CASE NO. SP2020-007

RE: REVISION NARRATIVE – AMENDED SITE PLAN SUBMITTAL

The following changes have been made to the previous approved site plan.

SPR PACKAGING
 OFFICE ADDITION
 1480 JUSTIN RD., ROCKWALL, TEXAS

2 WEST ELEVATION
SCALE: 1/8"=1'-0"

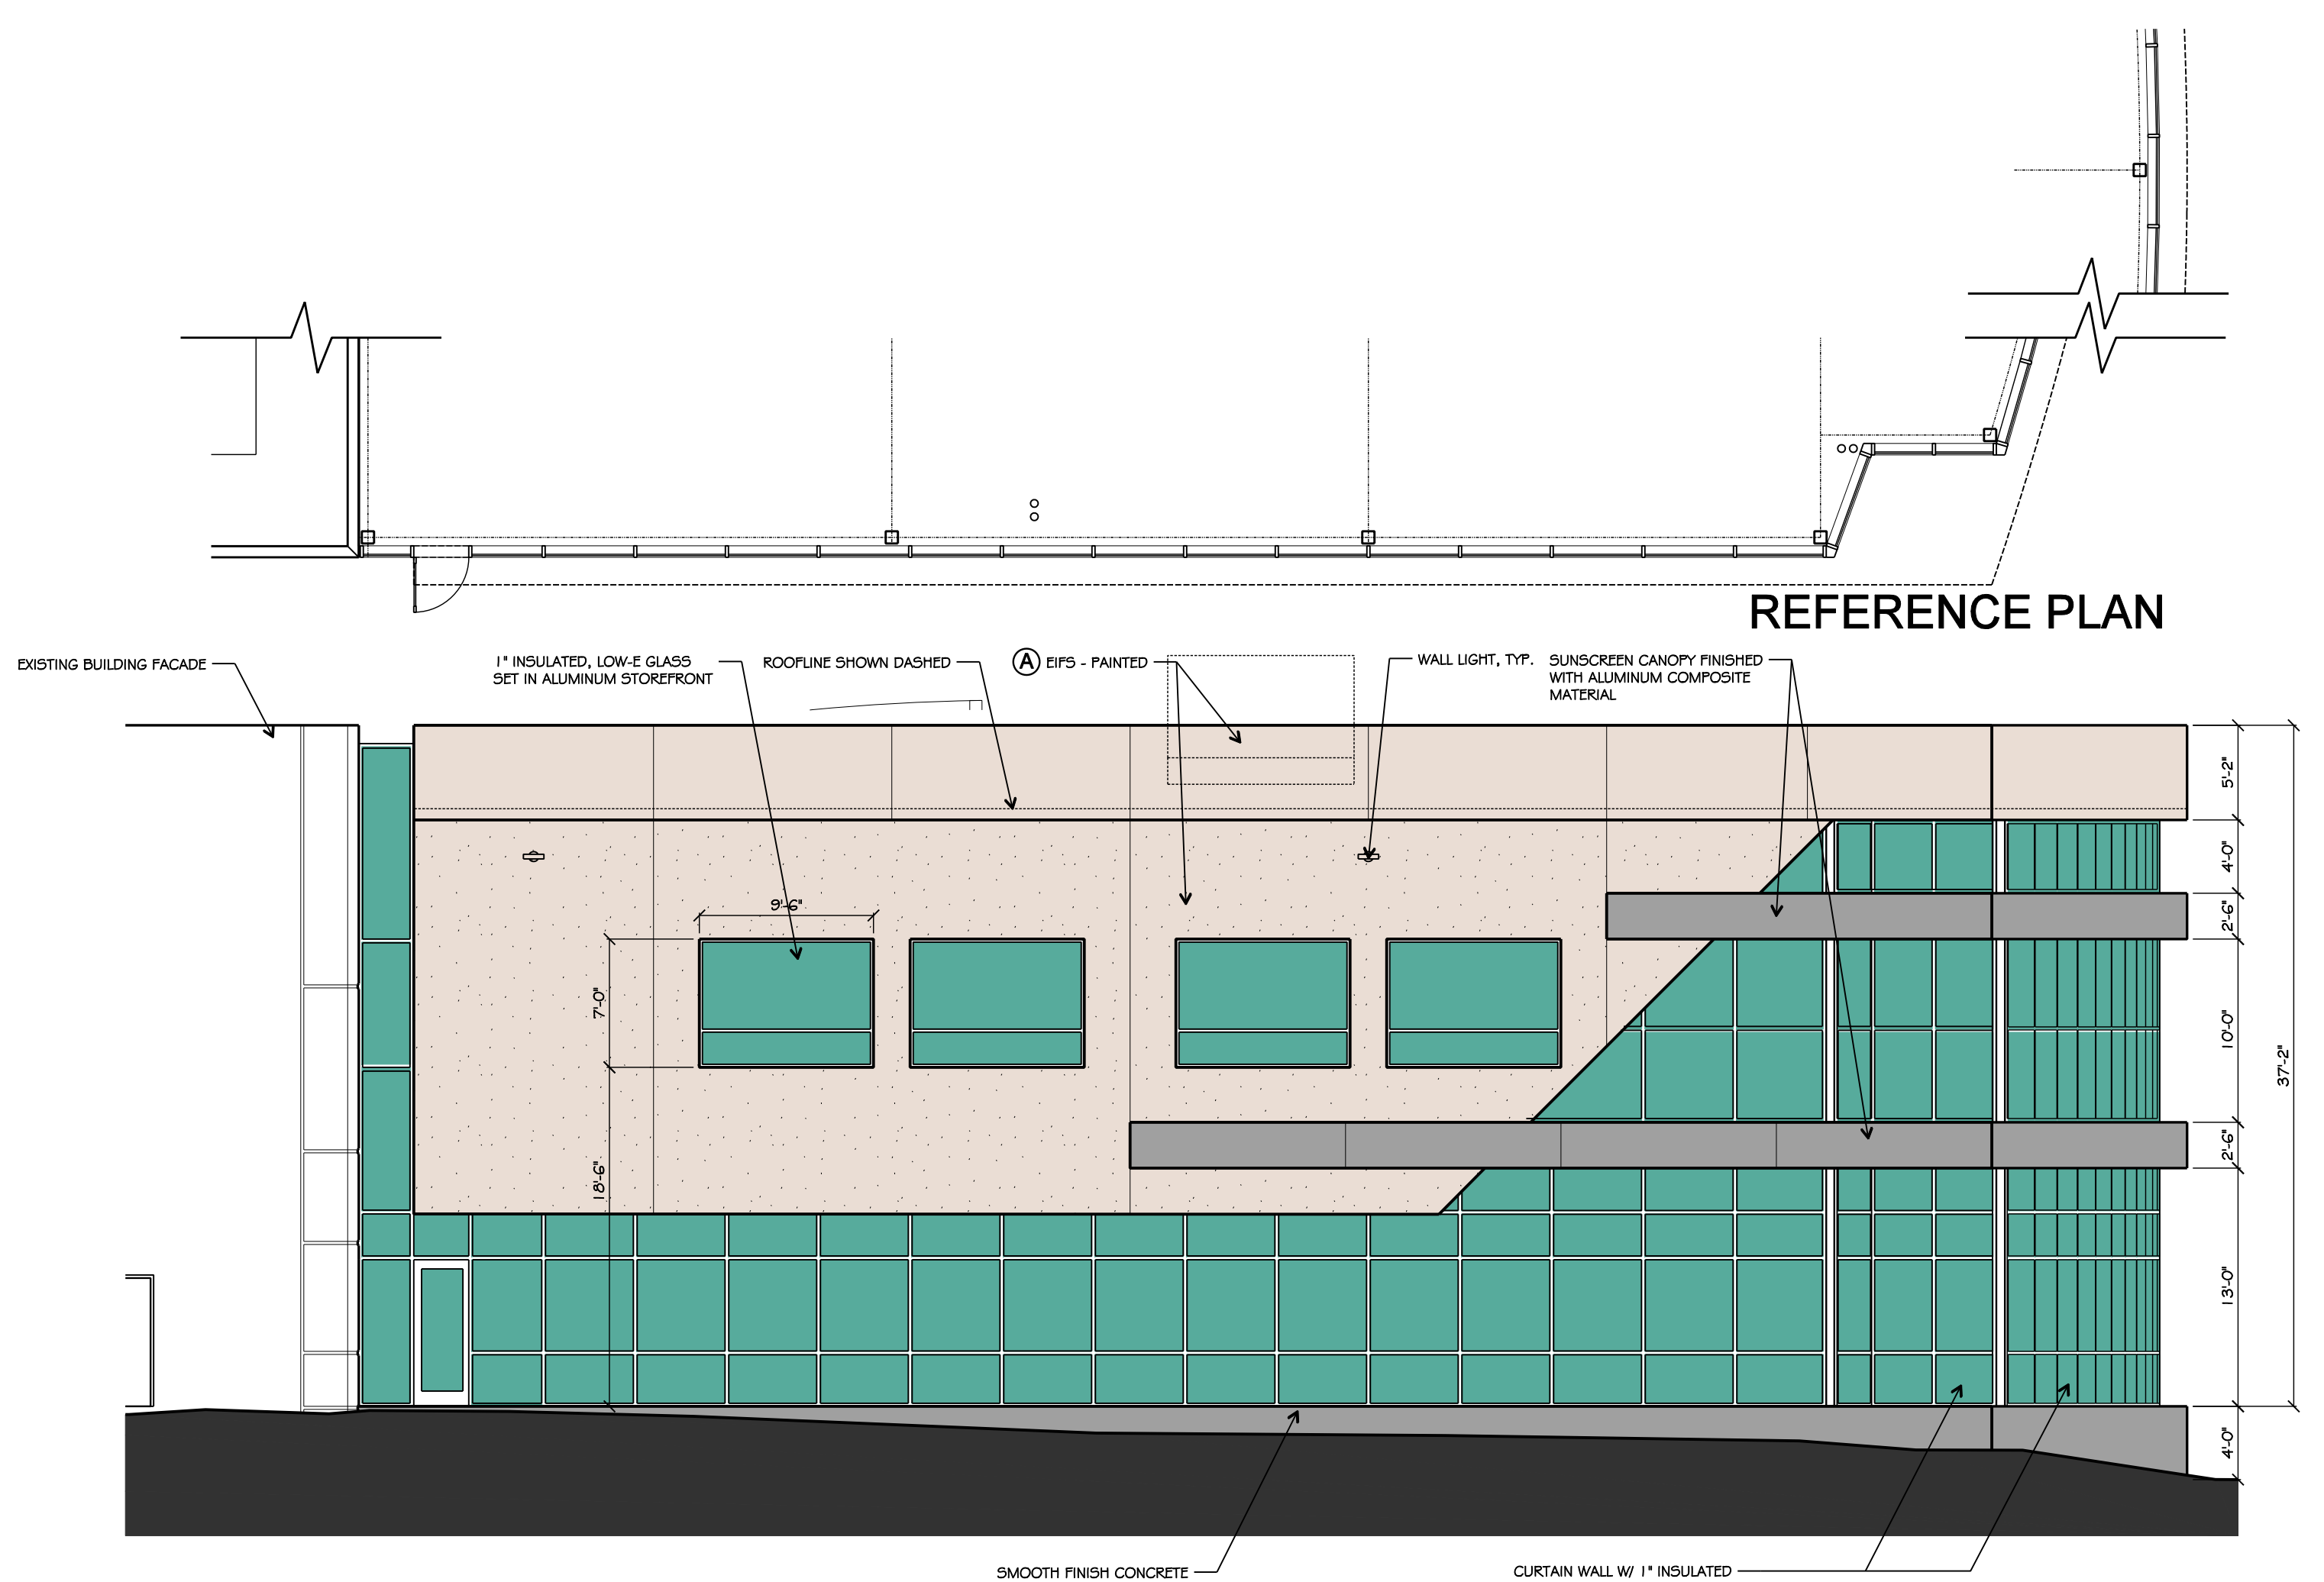
- Elevations are revised to show the new location of the compactor enclosure and the correct depiction of the entry stairs to the future locker room portion.

TREE PRESERVATION PLAN

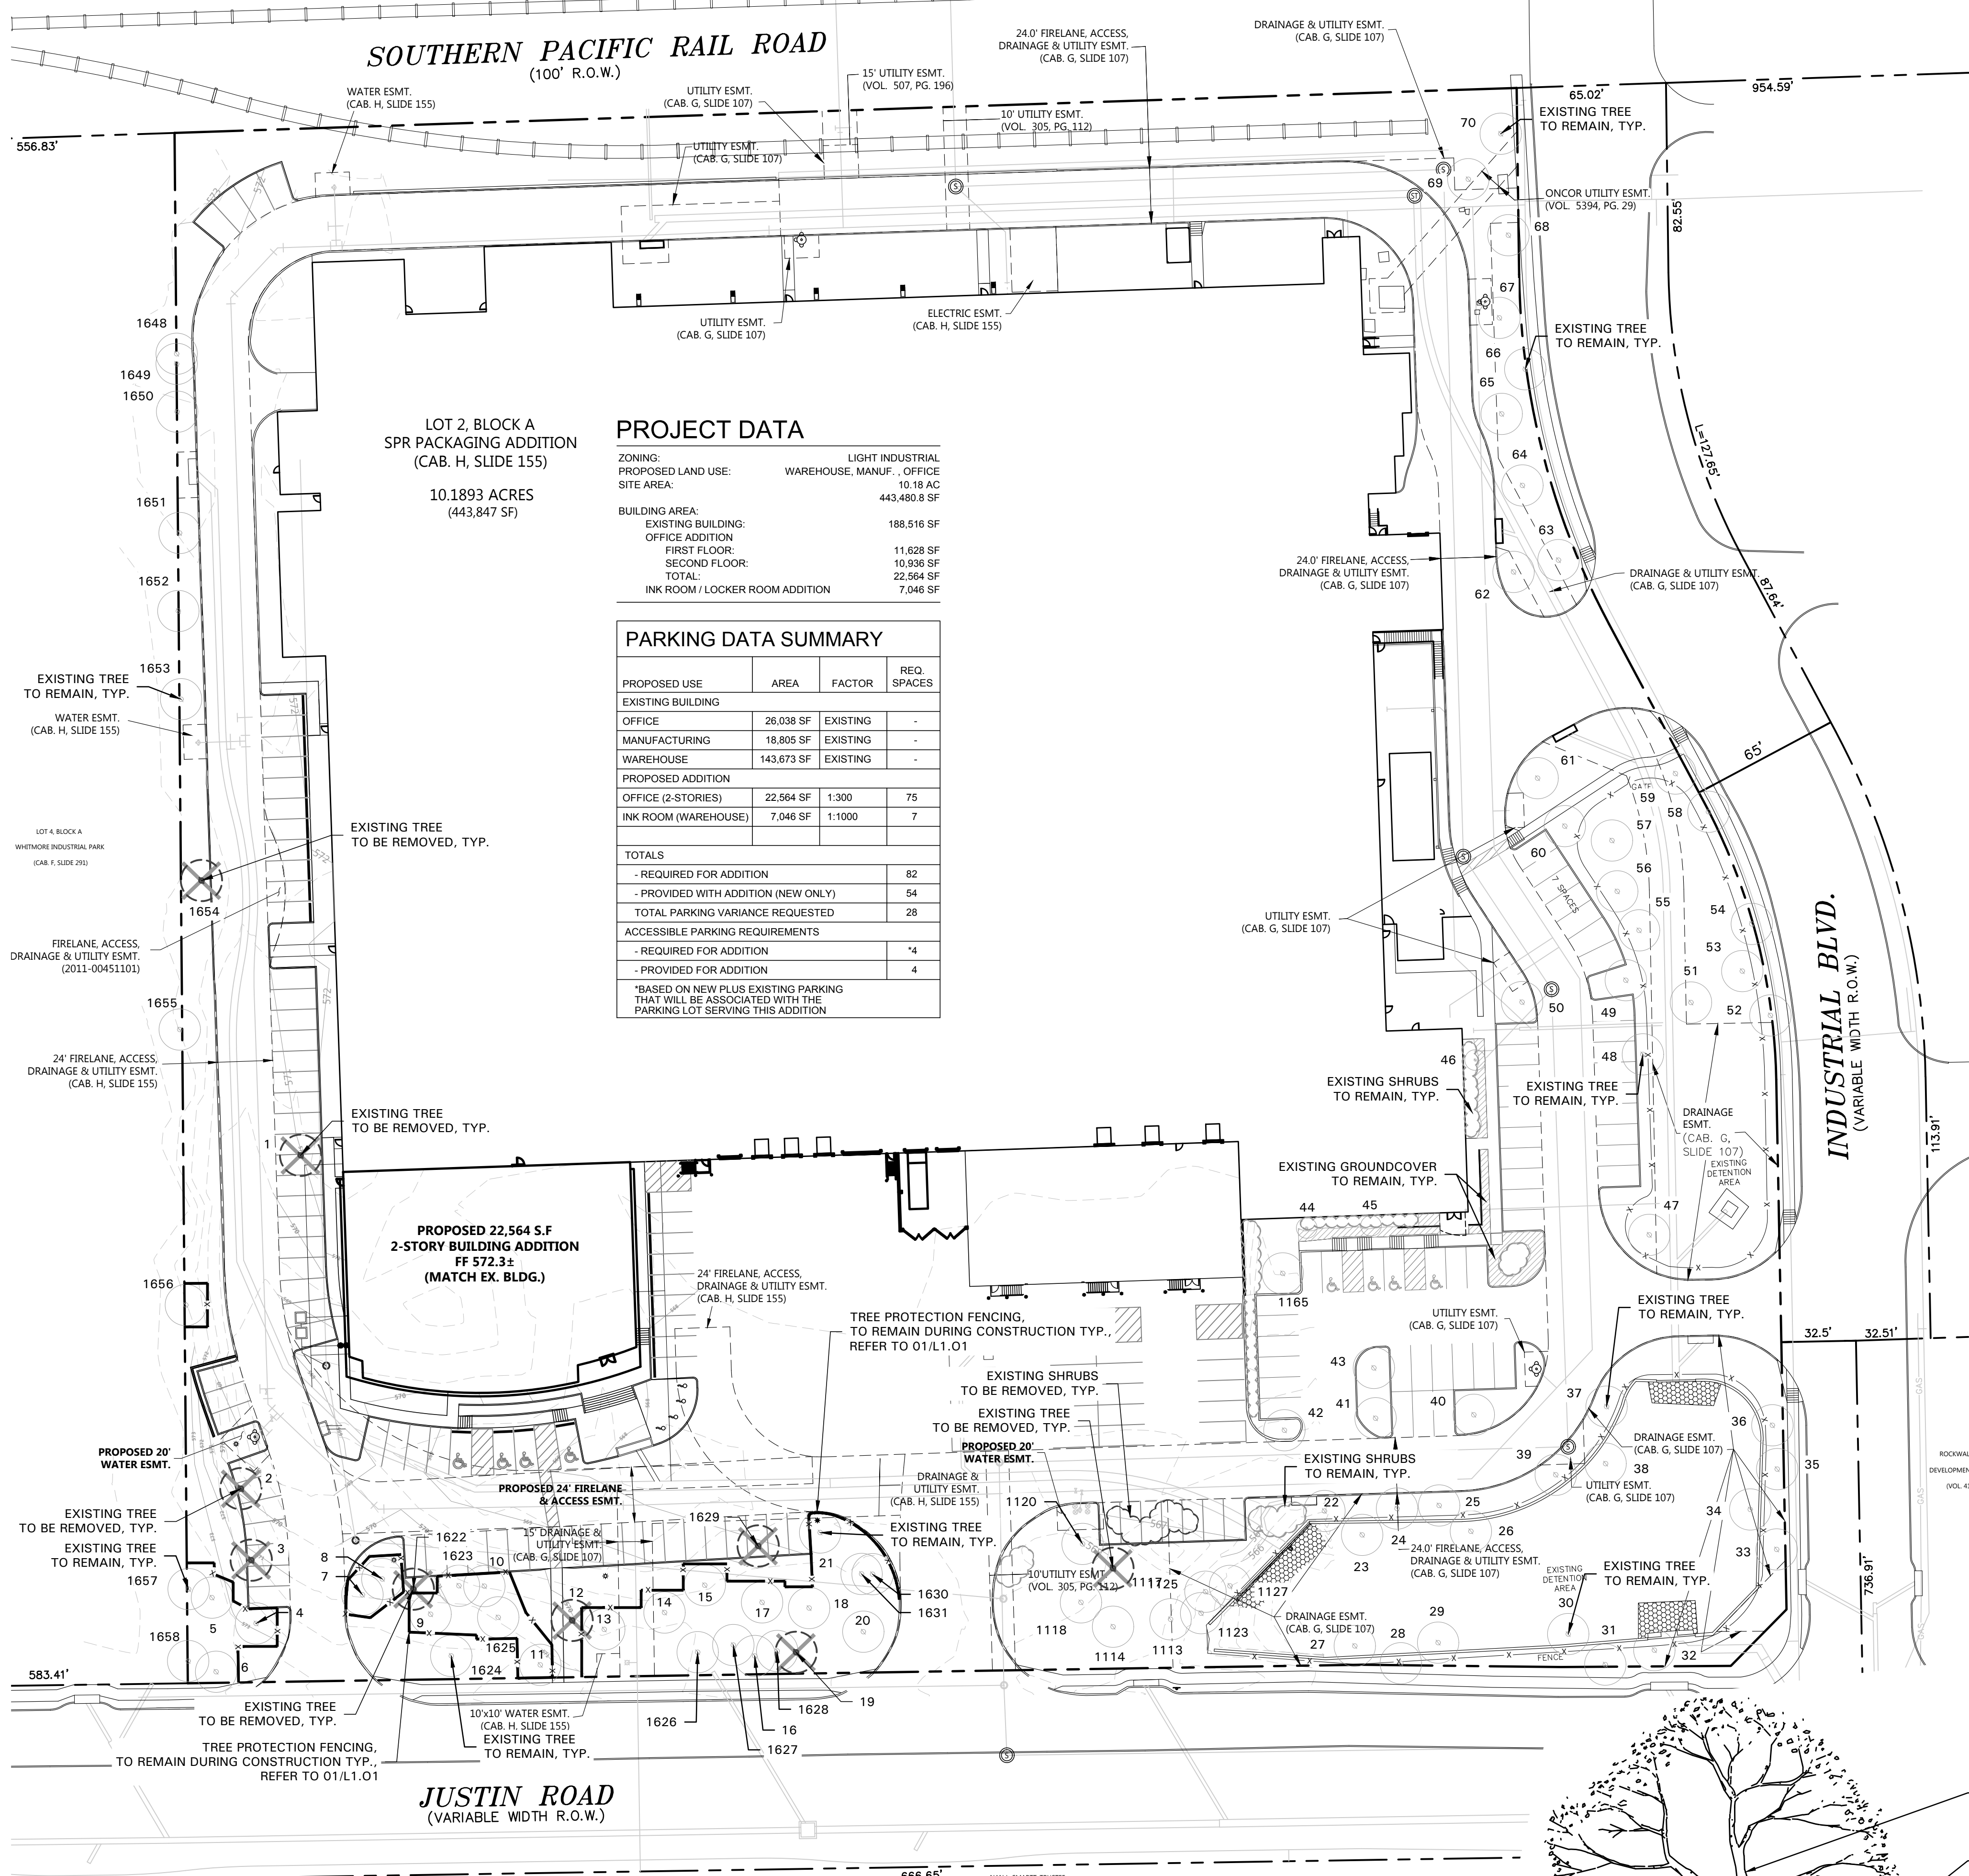
- Revised to show the removal of tree 1654 along the west drive.

LANDSCAPE PLAN

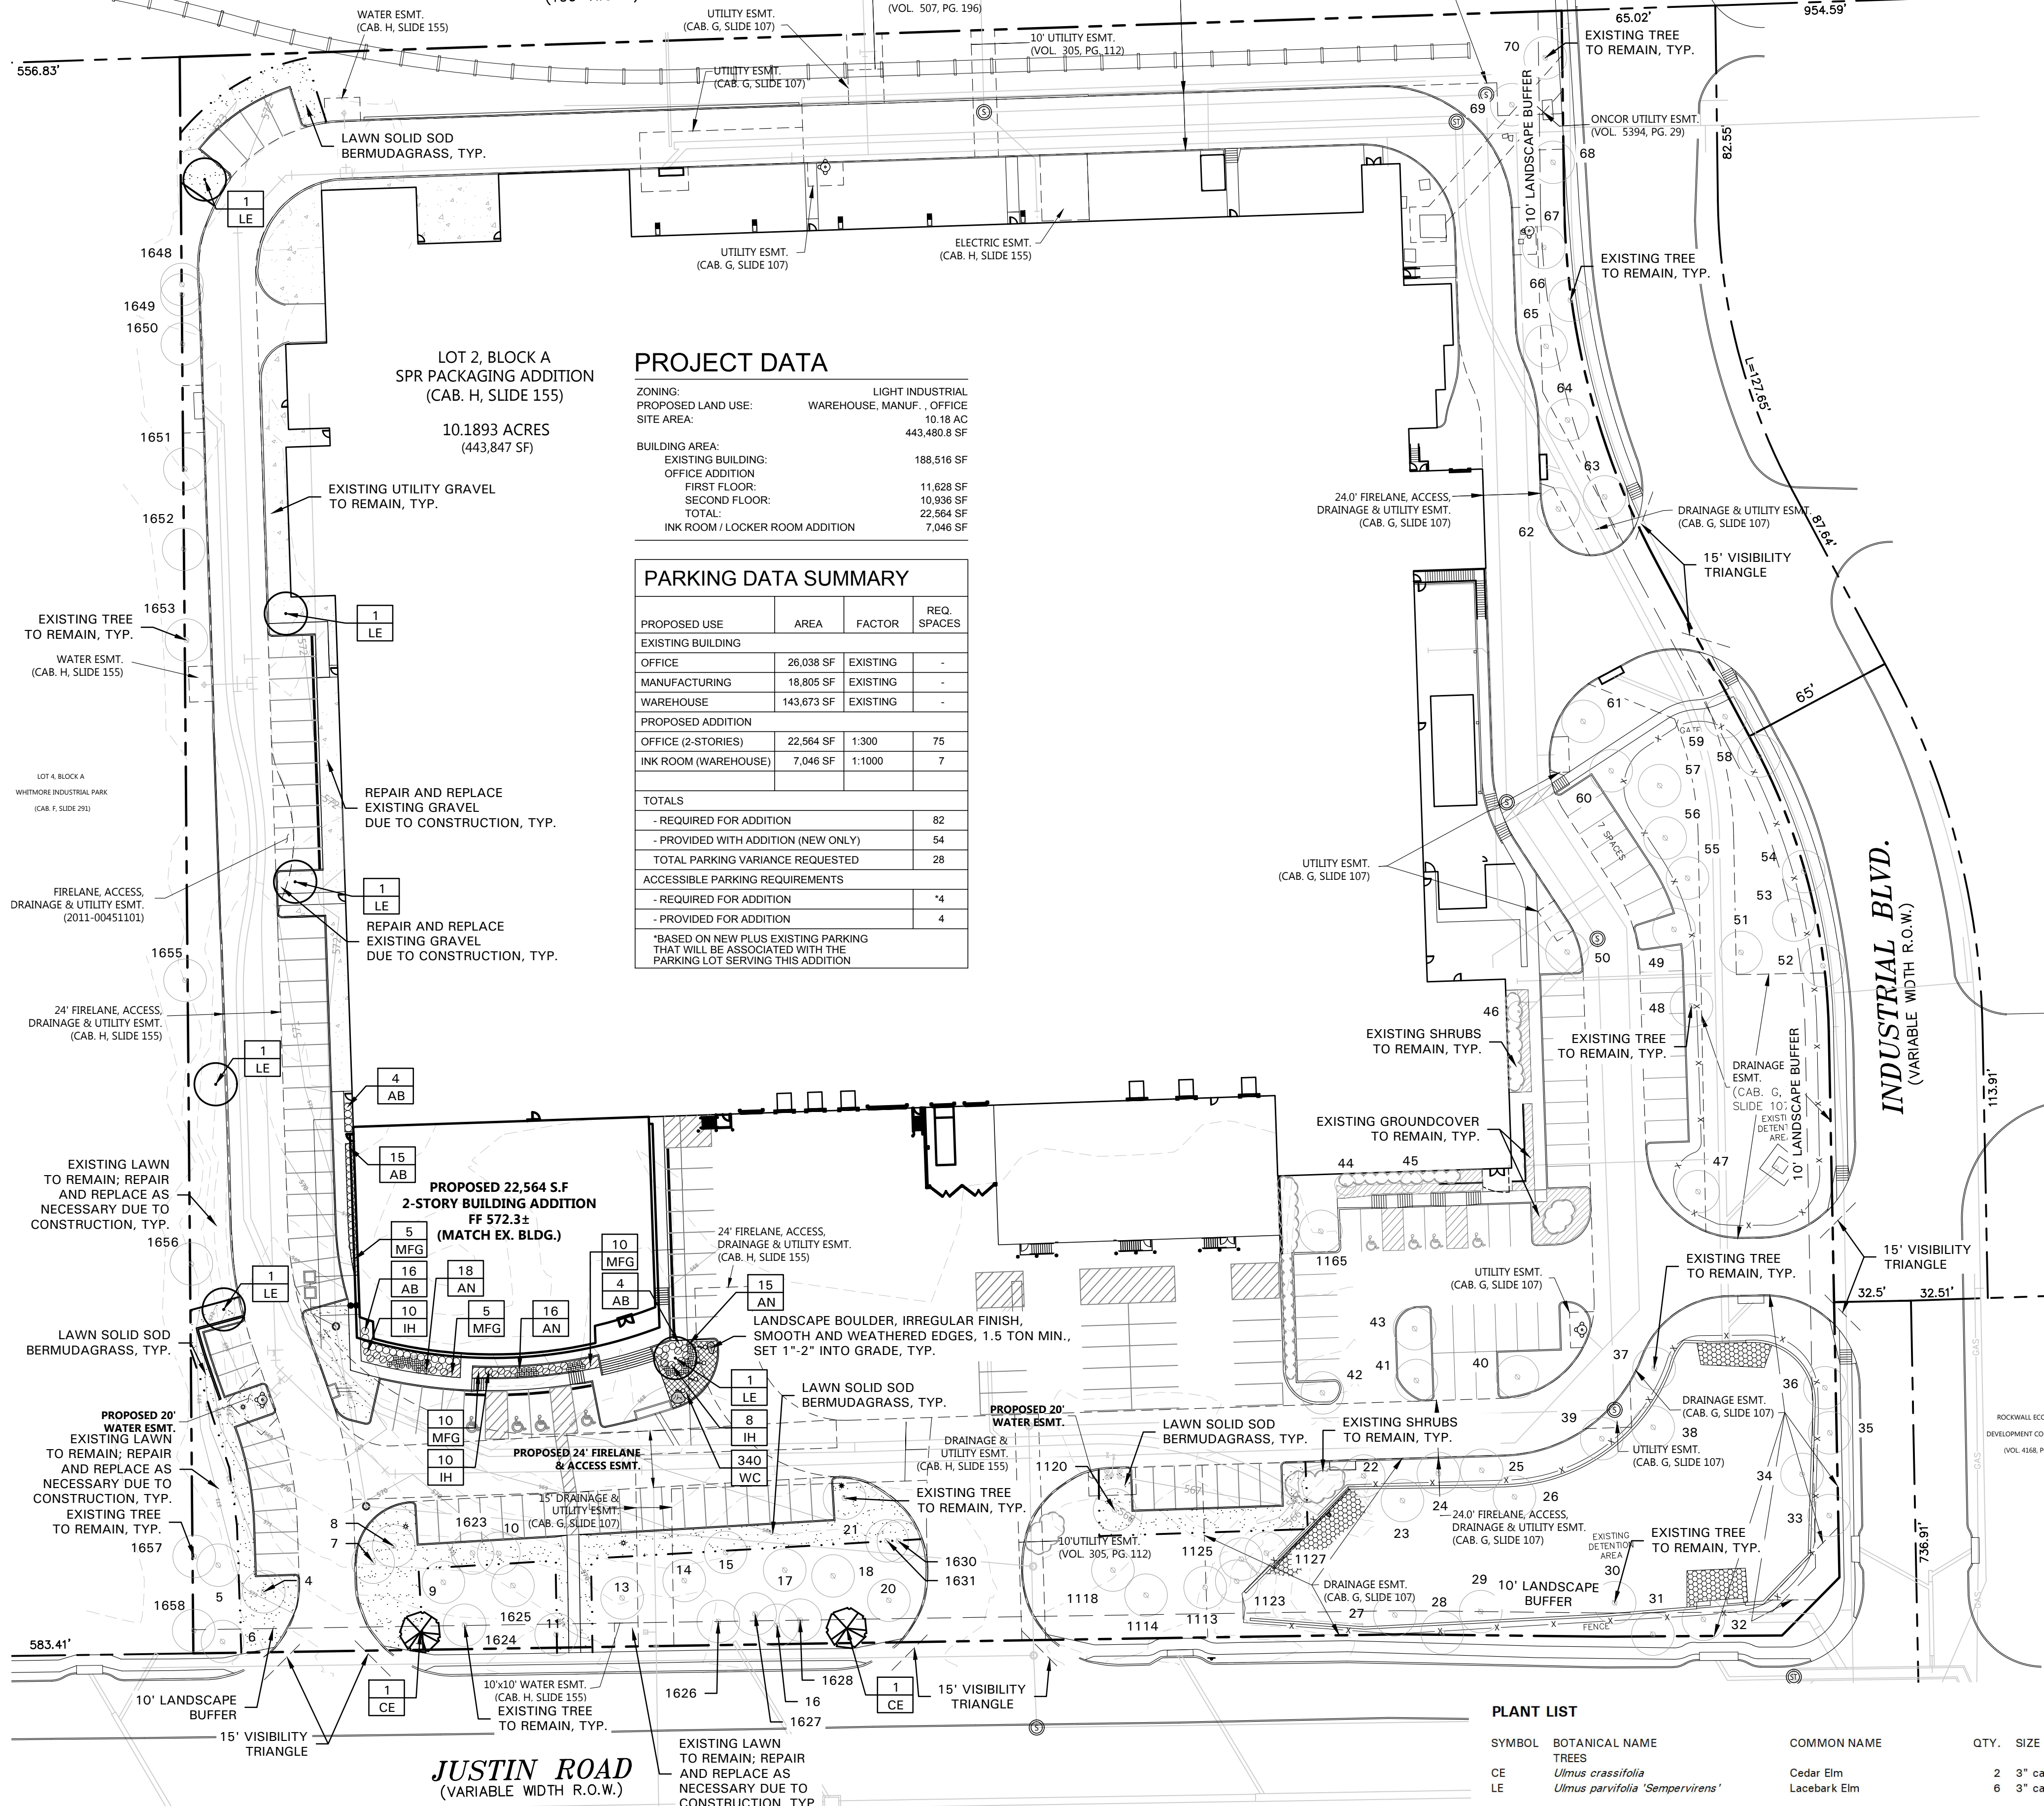
- Revised landscaping and tree location along the new parking configuration and affected drive areas.
